H.Henschel, I.Tsurin	
Title	VME interface and serial controller	
Size	Document Number BST Pad trigger system: Interface card	Rev 1
Date: Thursday, September 22, 2005	Sheet 2 of 5

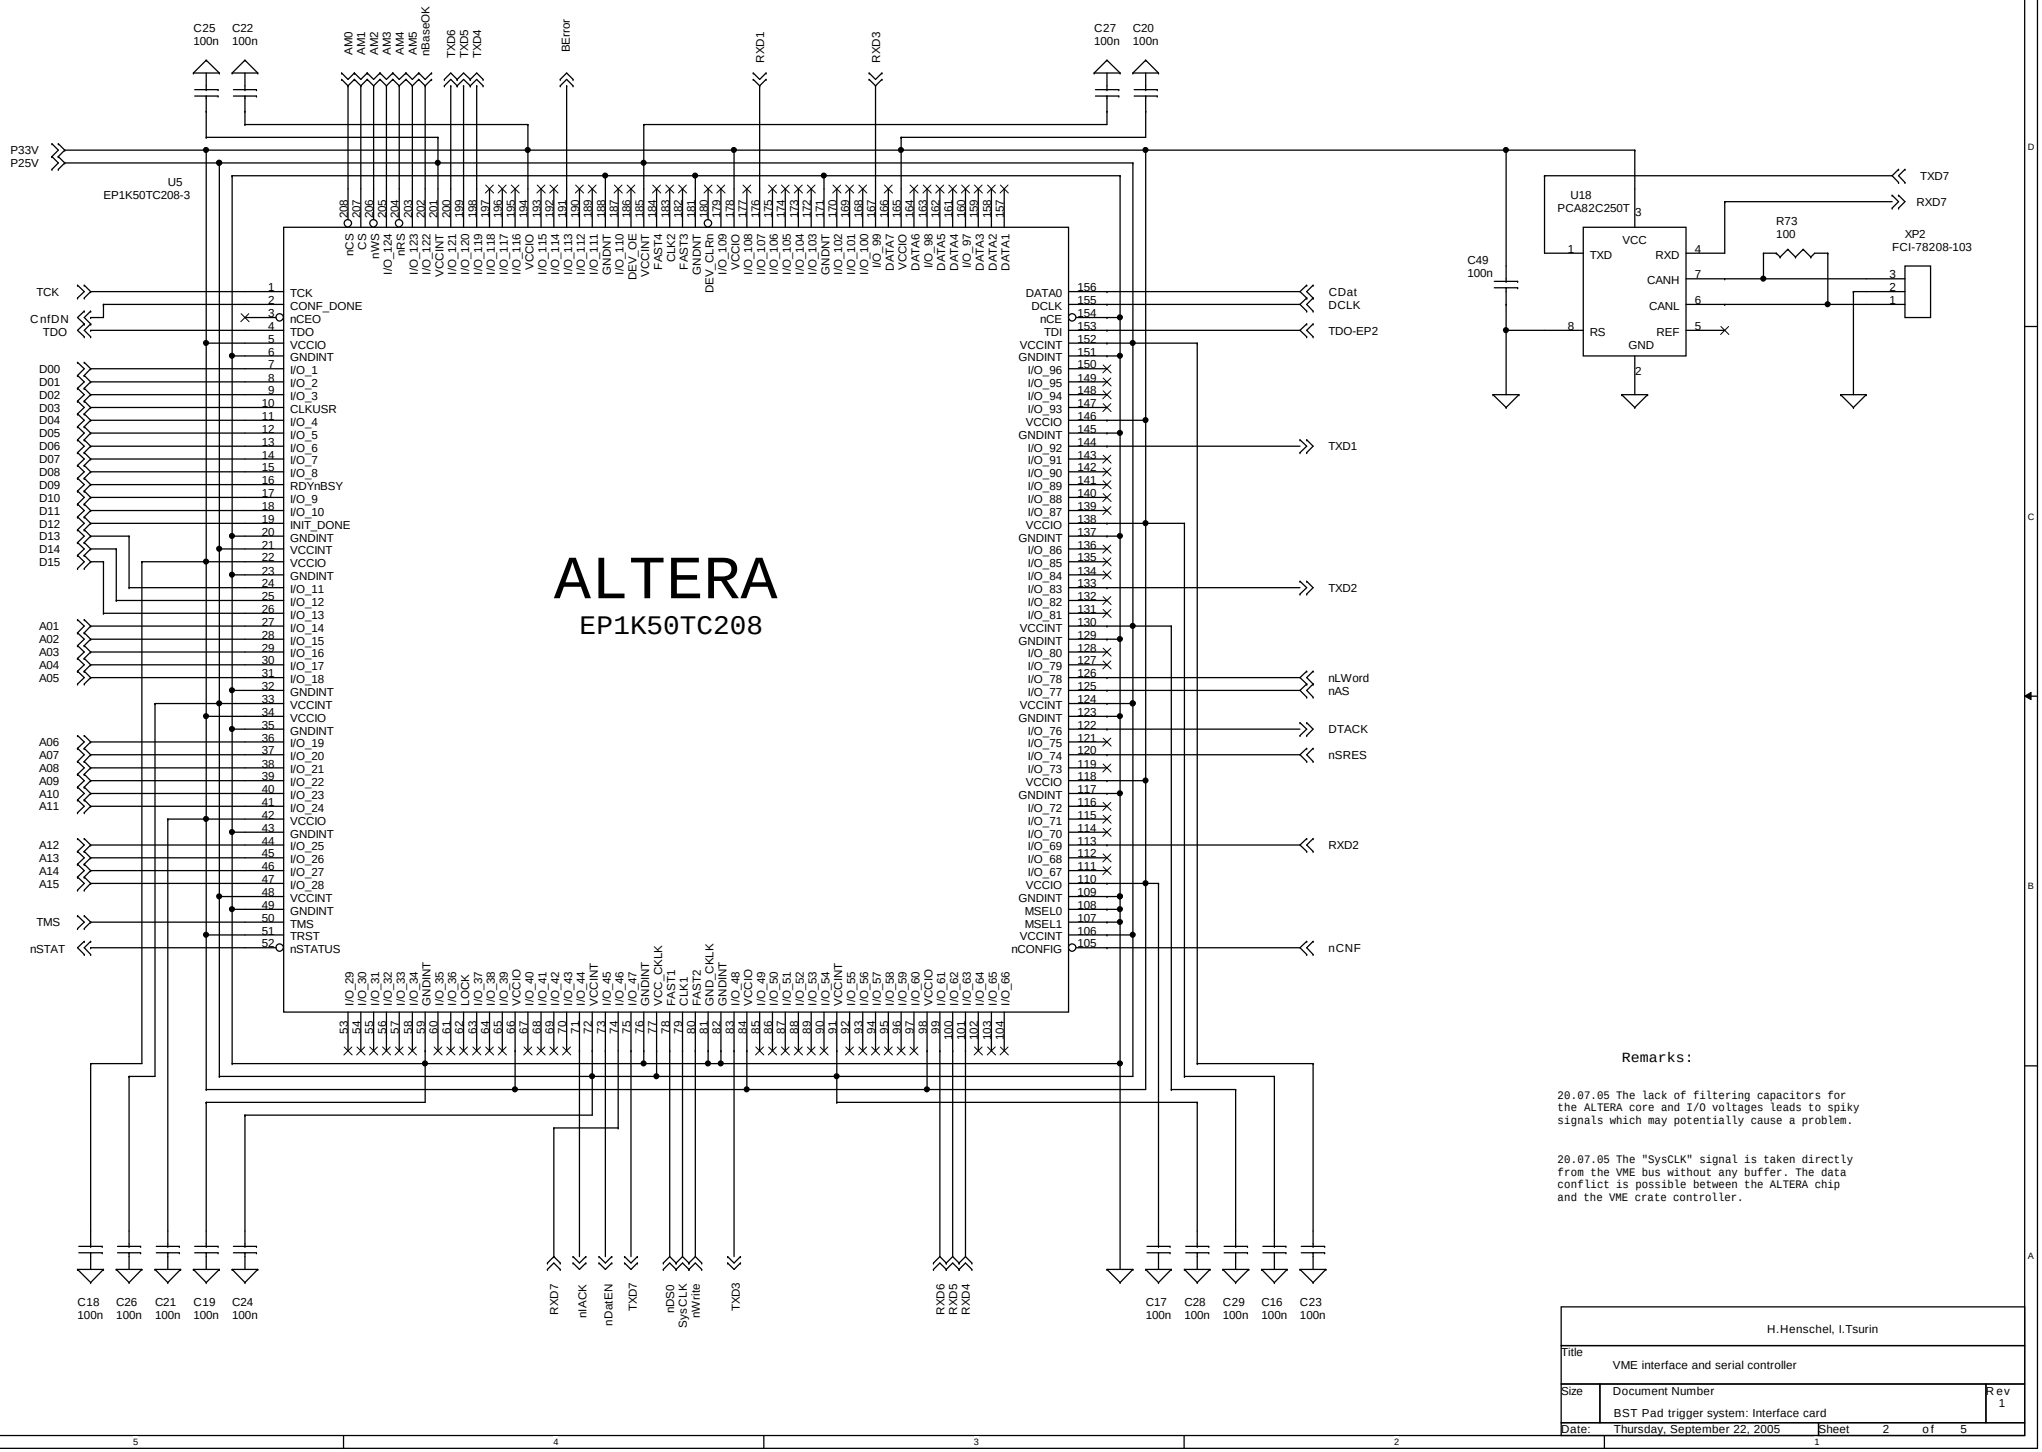
20.07.05 The lack of filtering capacitors for the ALTERA core and I/O voltages leads to spiky signals which may potentially cause a problem.

20.07.05 The "SysCLK" signal is taken directly from the VME bus without any buffer. The data conflict is possible between the ALTERA chip and the VME crate controller.
